Subject: SR 429 (Wekiva Parkway)/SR 417 and Interstate 4 Value Engineering Study  
Recommendation Dispositions.

FPID: 240200-4-52-01

## SR 429 (Wekiva Parkway)/SR 417 and I-4 Interchange

### Value Engineering Study **Draft** Report

**RECOMMENDATION No. 32: Increase the ramp profile to eliminate replacing the CR 46A Bridge**

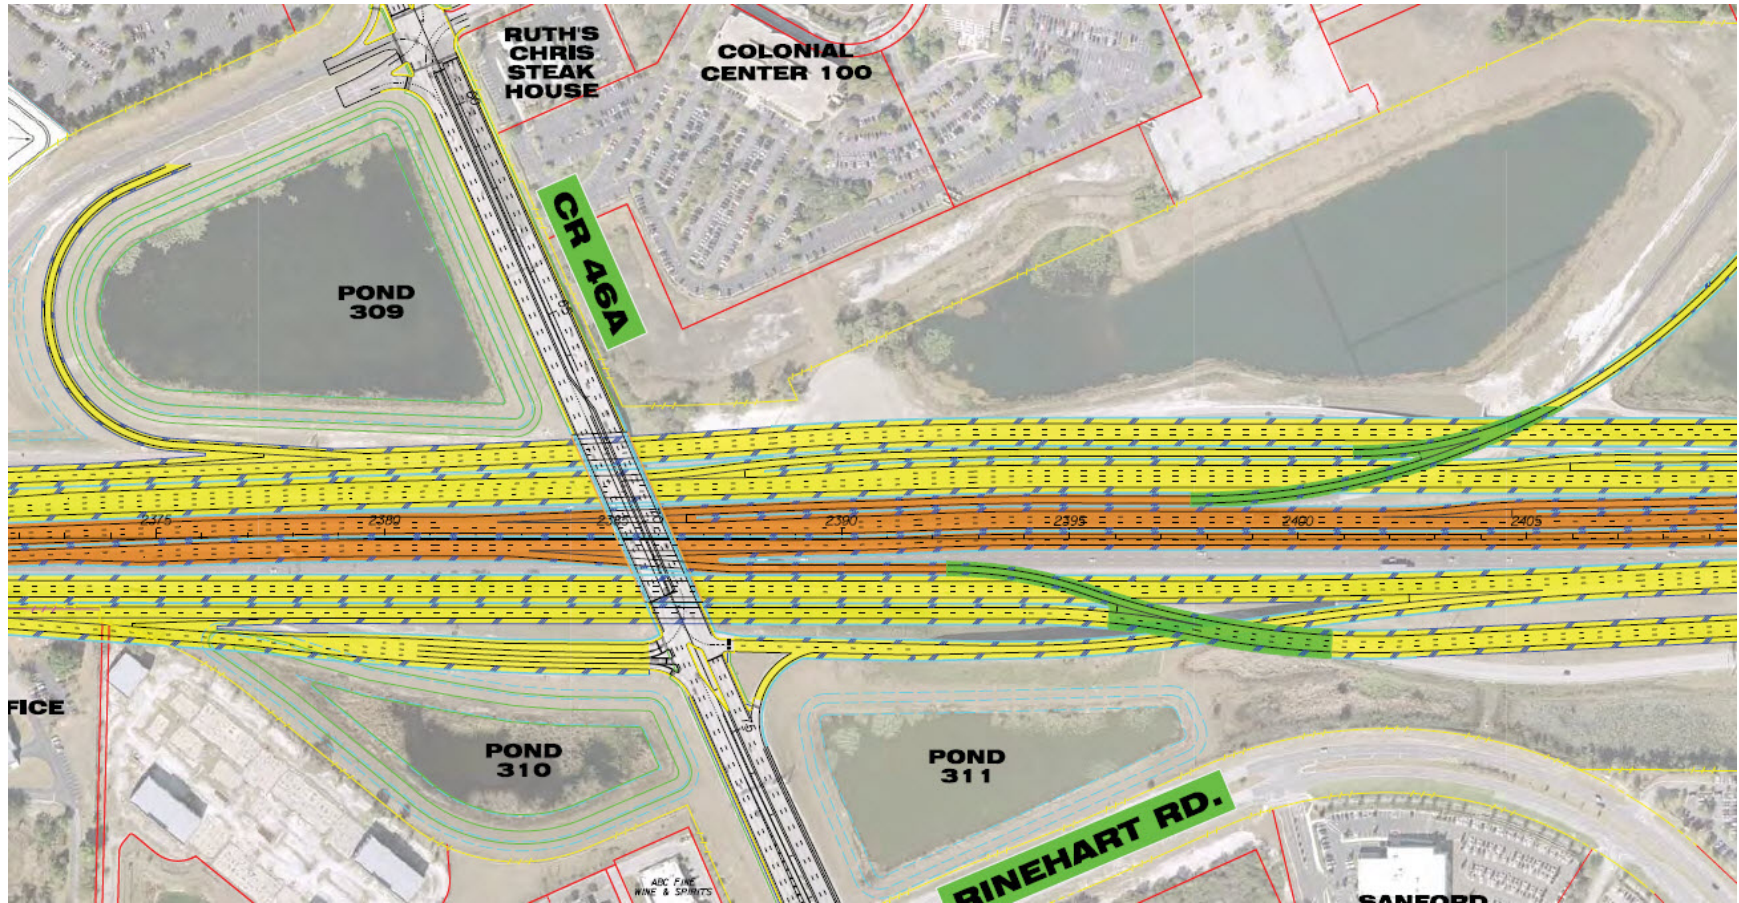
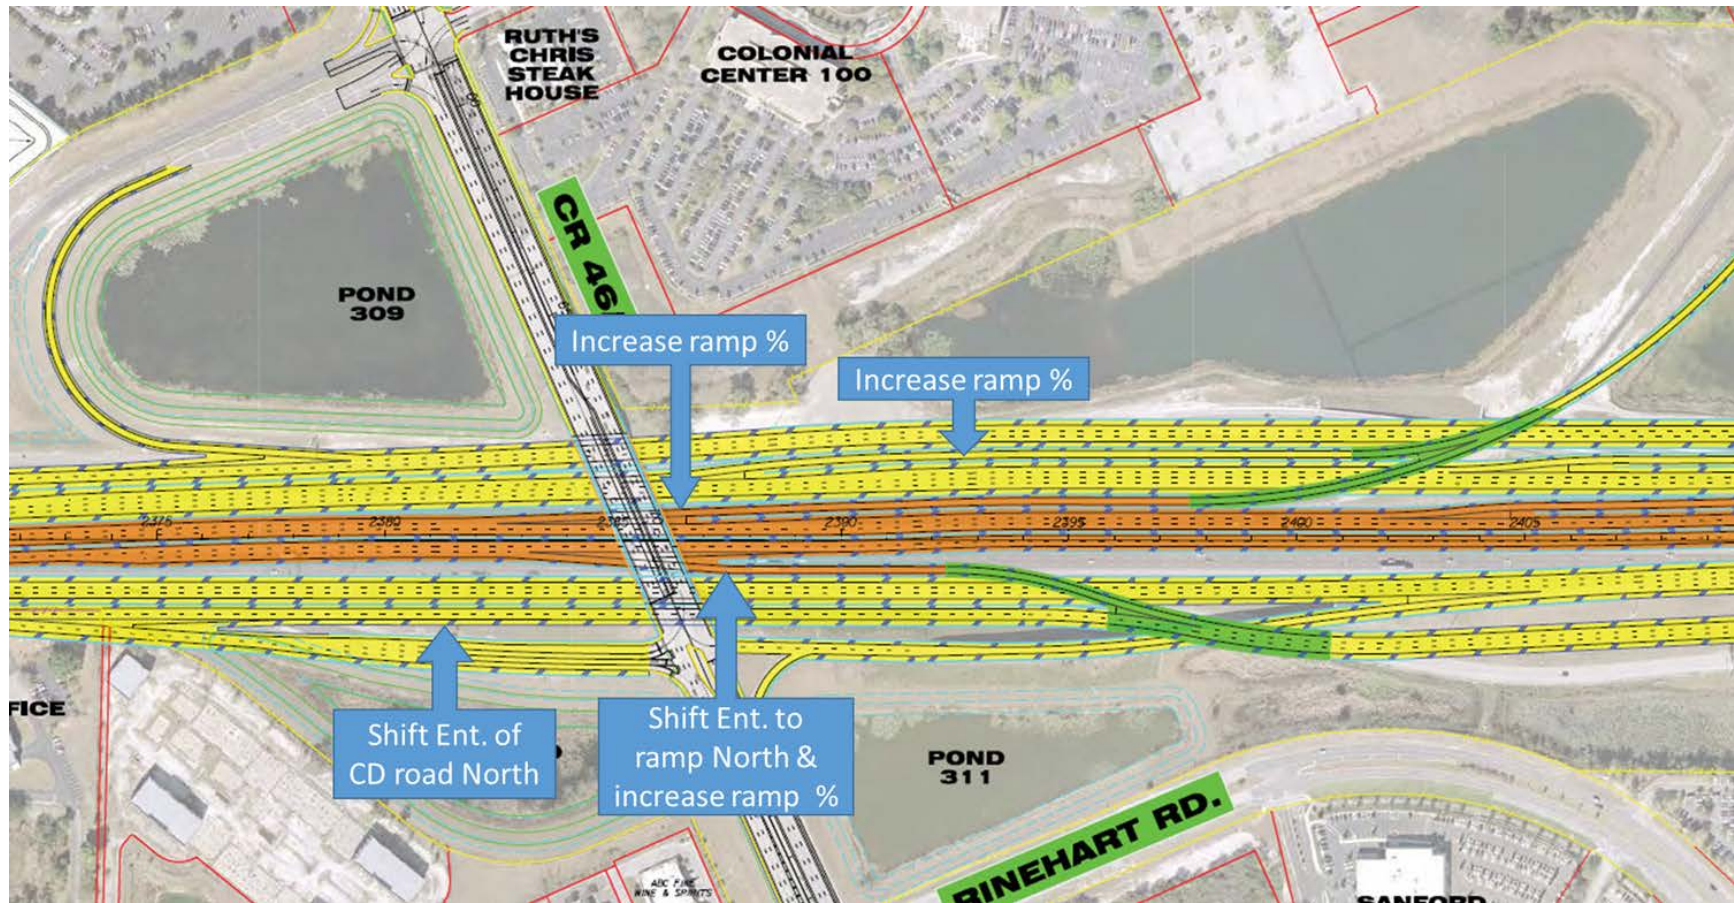
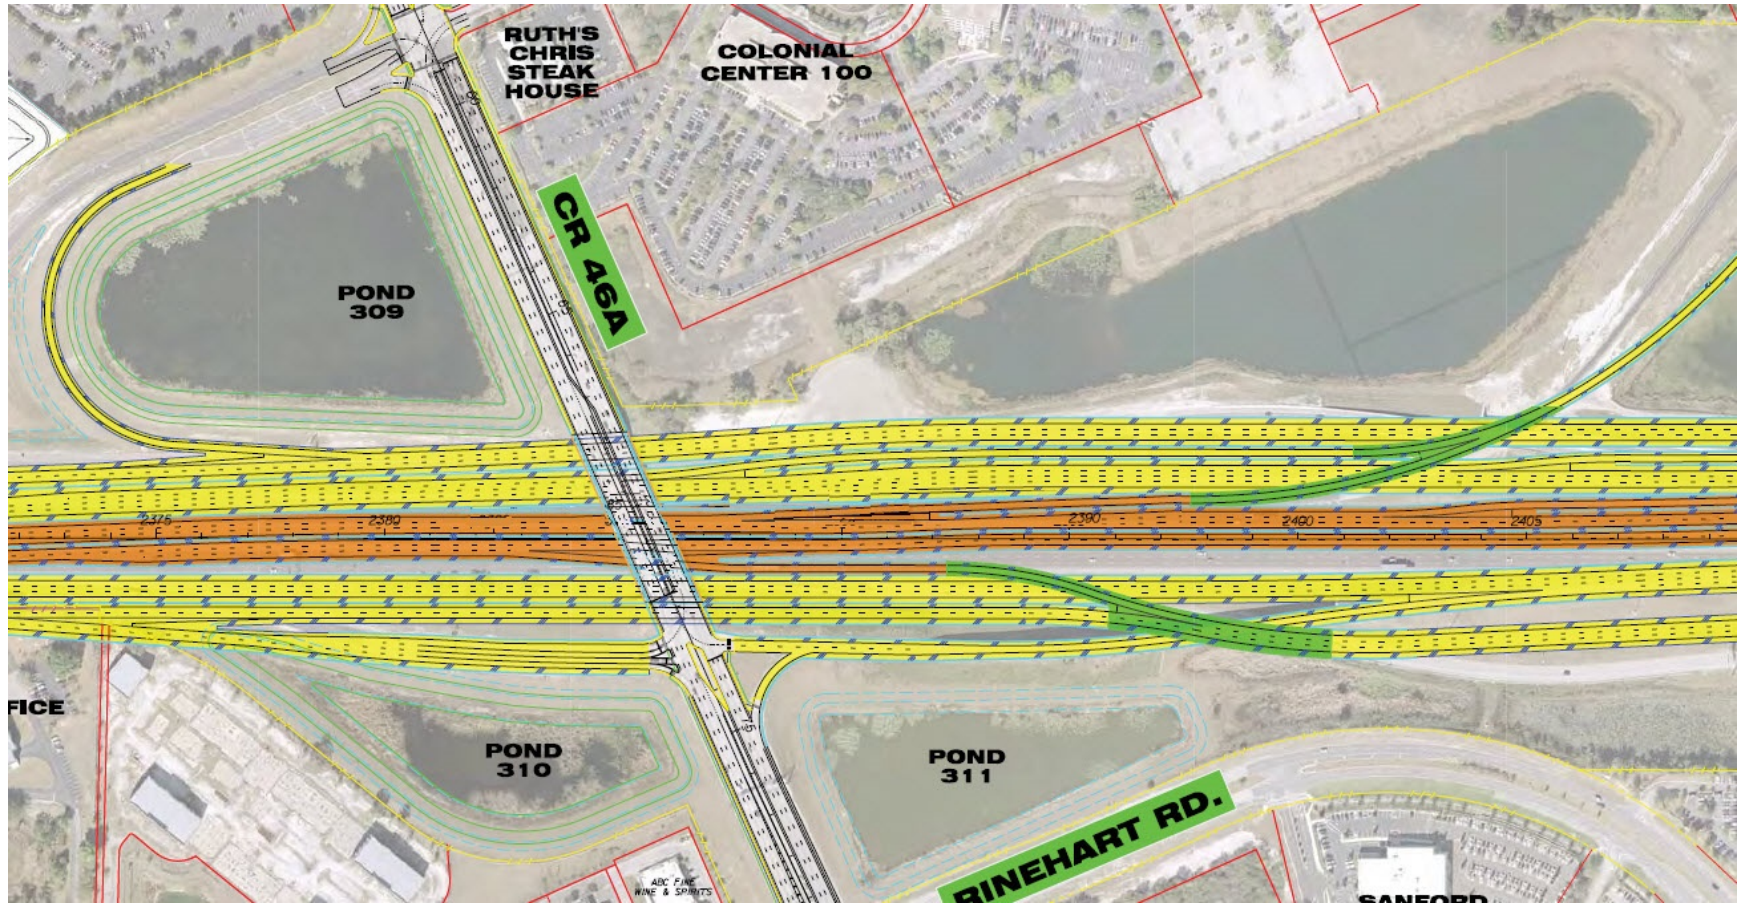
Recommendation 32: The VE Team recommends that ramp profile grades are increased to bring traffic to at-grade quicker (less distance), allowing traffic to merge into the mainline quicker, resulting in a narrow footprint of I-4. By reducing the overall width of I-4, the CR 46A Bridge does not need to be replaced as proposed.

Accepted. Ramp profile grades will be increased where possible.

**RECOMMENDATION No. 33: Cul-de-sacs for Wilson Road to allow for Wekiva Parkway to be at grade**

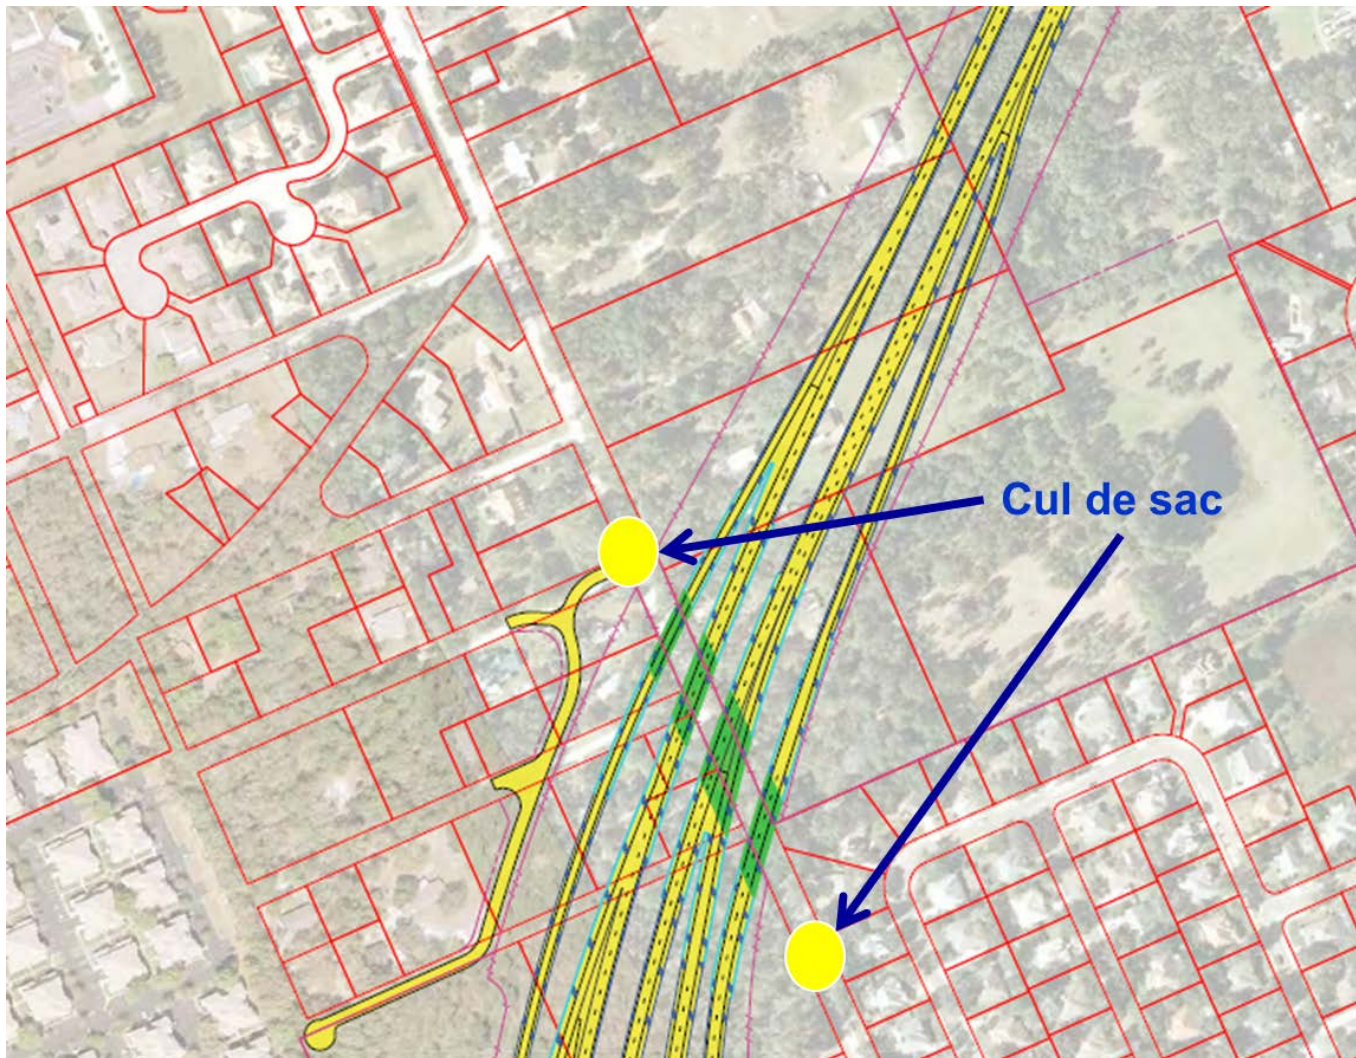
Recommendation 33: Cul-de-sacs for Wilson Road to allow for Wekiva Parkway to be at grade.

Rejected. Based upon discussion with Seminole County and the County Commissioner for this district they are not acceptable to constructing a cul-de-sac on this roadway. (Atkins)

**RECOMMENDATION No. 34: Don't construct the International Parkway Interchange with SR 429**

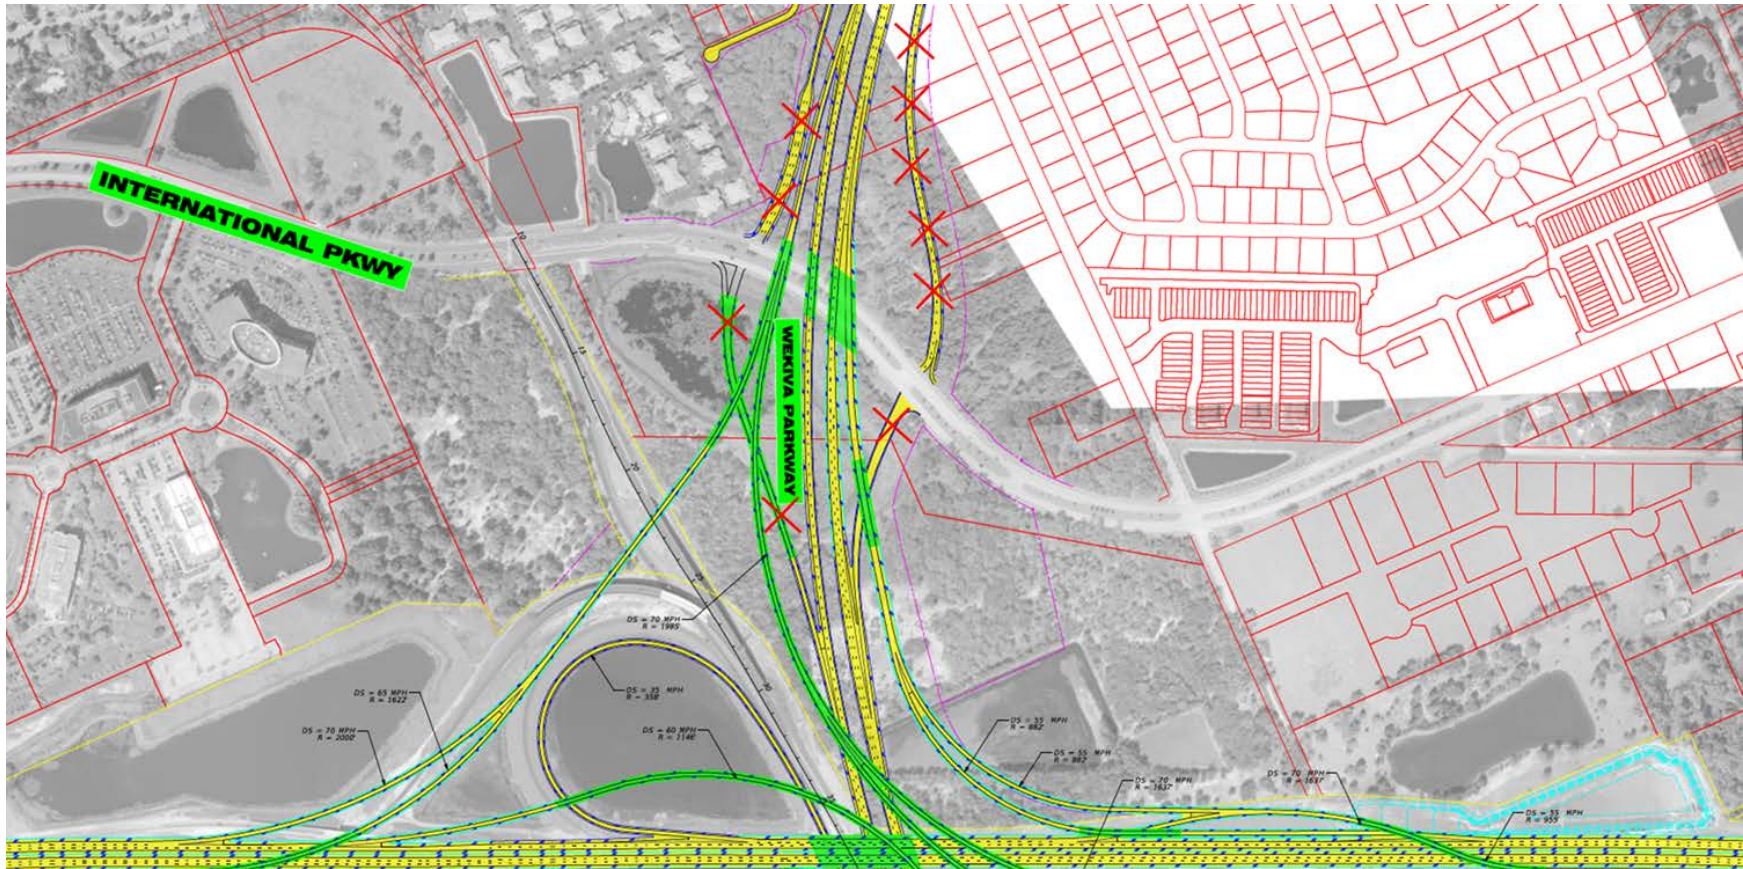
Recommendation 34: Don't construct the International Parkway Interchange with SR 429.

Rejected. Based upon discussion with Seminole County they are not in agreement to eliminate the interchange at International Parkway. This interchange is valuable to the development in this area and they would be opposed to not building this and to removing the existing connection they now have. (Atkins)
